Te Horo Hall

Seismic Strengthening Assessment of Effects on Historic Fabric

16 July 2024
Revision 2

Figure 22: Proposed floor plan of the Te Horo Hall (NTS). Source: Seajay Consultants.

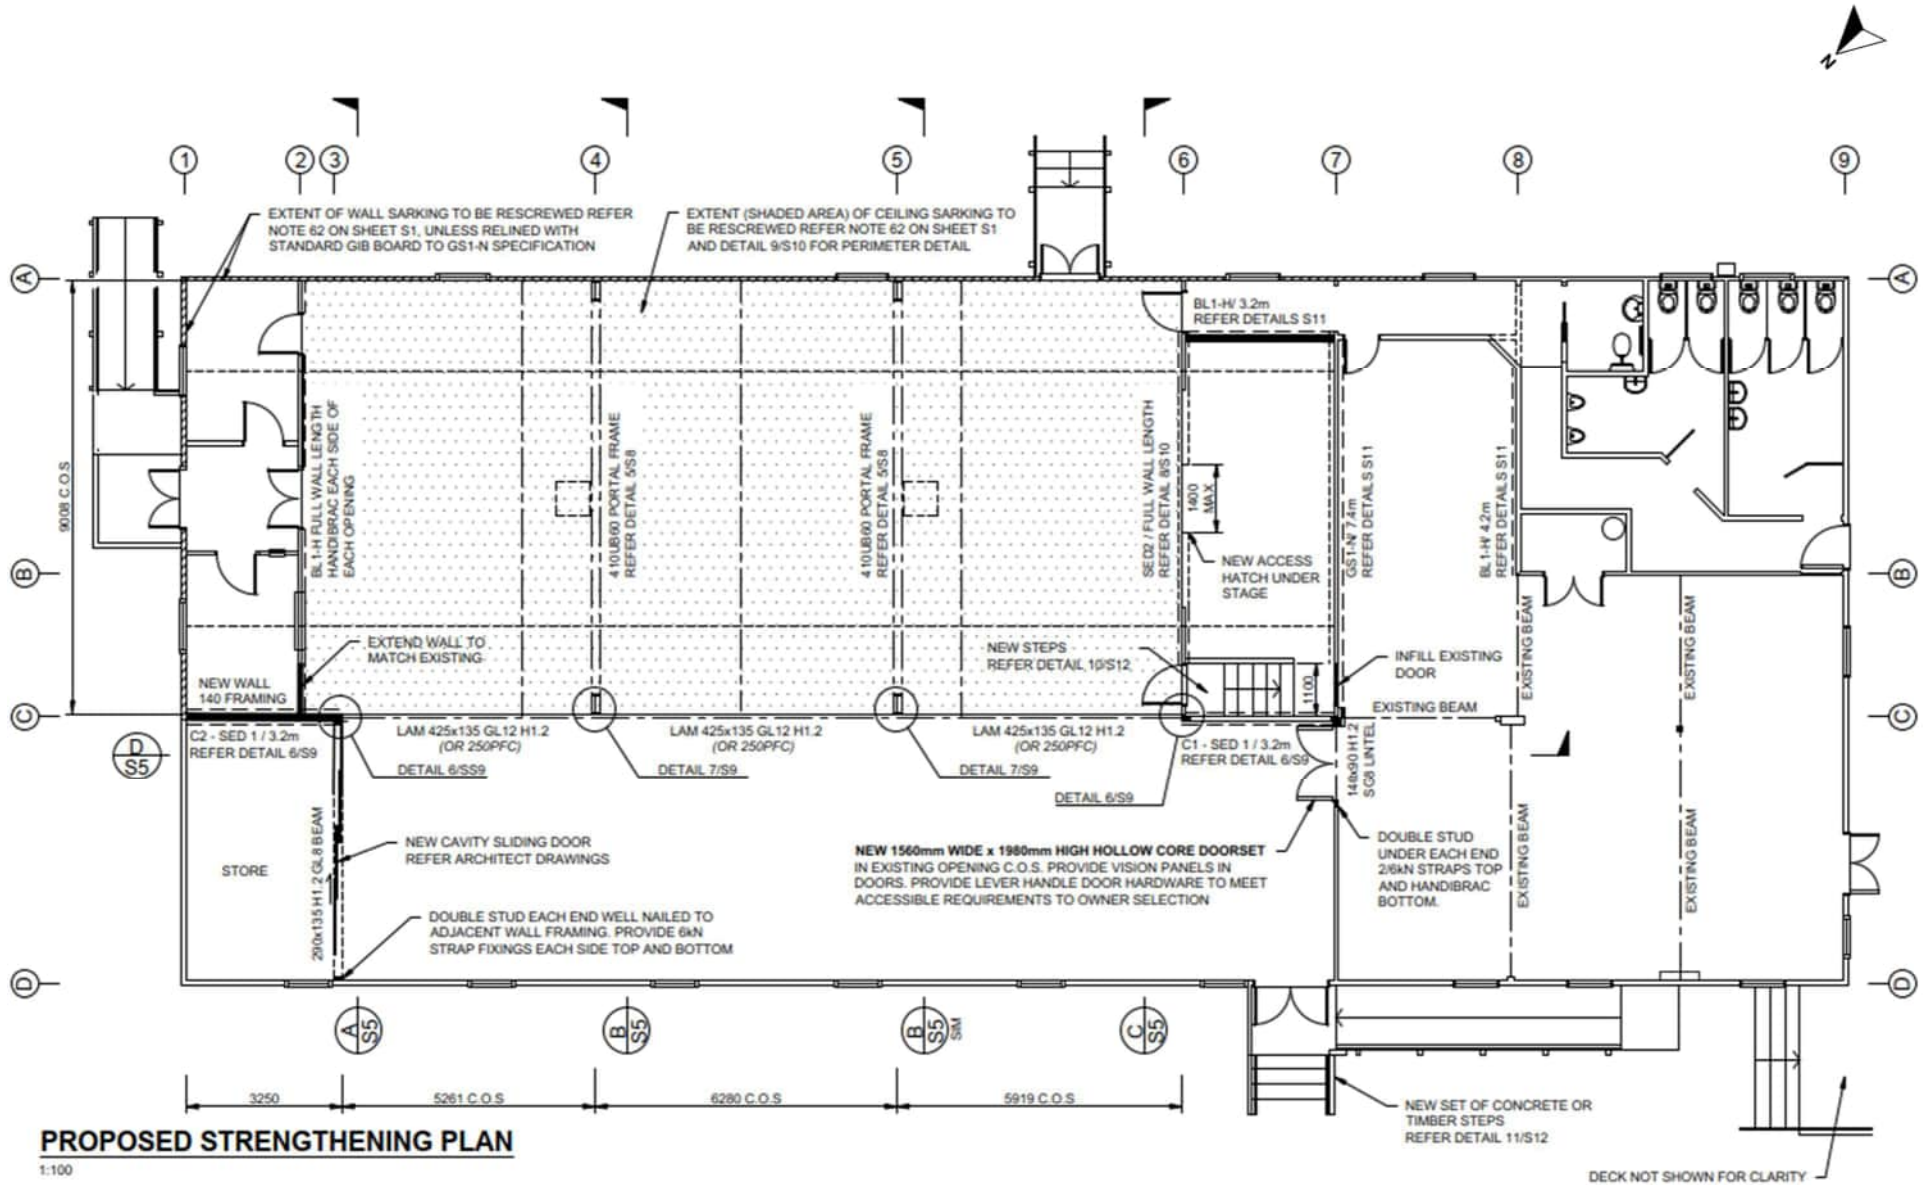
- Two transverse steel portal frames that follow the line of the vaulted ceiling are to be added within the main hall. The steel is to be painted, but is not to be boxed-in.
- The existing timber TG&V vaulted ceiling is to be re-screwed.
- Bracing elements, in the form of GIB board or plywood, are to be added to walls in both directions. In some cases, this will include introducing new elements into the wall frame to support the linings.
- New pads, anchor piles and braced piles are to be installed. This will require access from above through the floor as there is not sufficient room in the subfloor for the excavation and construction works to be undertaken.
- A new beam is to be installed at the junction between the main hall and the annex.
- New bracing walls are to be added to the main hall and either side of the stage.

New servery on gridline 2	N/A	It is proposed to create a servery to the ticket office in this wall. This will require removal of fabric from the original wall, which is an adverse effect. The drawings do not include any detail about the servery in terms of its frame, architraves, or sill.	Minor Adverse	<p>It would be preferable to position the servery in the section of new wall to be constructed, that way any loss of existing fabric would be avoided, and the adverse impact would be reduced to negligible.</p> <p>The servery opening should be framed in timber, have architraves that match those of the adjacent doors on both sides, and be painted out to match other timberwork.</p>
	New wall on gridline 2	N/A	A small length of wall on gridline 2 is to be installed to restore the ticket office to its original rectangular shape. The drawings state that this is "to match existing". Reinstatement of the wall is a beneficial effect as it restores the original wall line; however, there are no details of the wall linings or finishes.	Unknown	Assuming that the recommendation above to restore the TG&V linings on this wall is followed, the new area of wall should be lined with TG&V salvaged from other parts of the building (for example, the wall on gridline 6) where TG&V has to be removed.

Room	Fabric Item	Significance	Explanation	Effect	Recommendations
	Timber T&G floorboards	Exceptional	The floorboards are an original feature of the building and are in good condition. The drawings indicate that there will be new footings and pads for the portal frames on gridlines A and C, three further new pads on gridline C, and anchor piles along gridline 2 below the wall line and threshold of the doors to the foyer and cloakroom, and braced piles on gridline 6 below the stage edge. Floorboards will need to be lifted to get access for installing these new foundations. Damage to, or loss of, this original fabric will be a moderate adverse effect.	Moderate Adverse	The condition of the existing fabric should be photographically recorded prior to, during, and at completion of the works. If possible, access to the foundations on gridline C should be created through the floor of the annex and the work undertaken without touching timber floorboards. Floorboards should be carefully removed in full lengths only, and should be reinstated in their original locations, with all works carried out following a methodology that has been approved by a heritage specialist. If this recommendation is followed, and the methodology is carefully carried out by the contractor, the disturbed areas should not be visible, and the adverse effect would be reduced to negligible.

- Removal of the foldable stage wings either side of the raised stage, which are elements that have exceptional significance.
- Removal of historic T&G floorboards in the foyer, main hall, cloakroom ("cupboard"), ticket office, stage area and anteroom for new foundations.
- Removal of historic timber TG&V ceiling fabric in the main hall due to fly braces attached to the portal frames and above the stage due to wall linings.
- Removal of an original door between the stage and anteroom.
- Removal and replacement of architraves to doors and windows for wall lining works.
- Application of sheet linings (GIB or plywood) over historic timber TG&V wall linings.

- Avoid or minimise damage or removal of significant fabric by:
 - Remove flooring from the annex to access the sub-floor for foundation works to reduce the need for removing floorboards from the main hall and ticket office area.

- Remove flooring from the kitchen/dining area to access the sub-floor for foundation works to reduce the need for removing floorboards in the anteroom area.

- Ensure ledges in the walls on gridlines A and C that provide the seats for the foldable stage wings remain in place.
 - Ensure the full height wall at the SE end of the stage, and the partial-height wall at the NW end of the stage (which incorporates the barrier for the accessible stair) do not encroach in any way on the fixed stage floor.
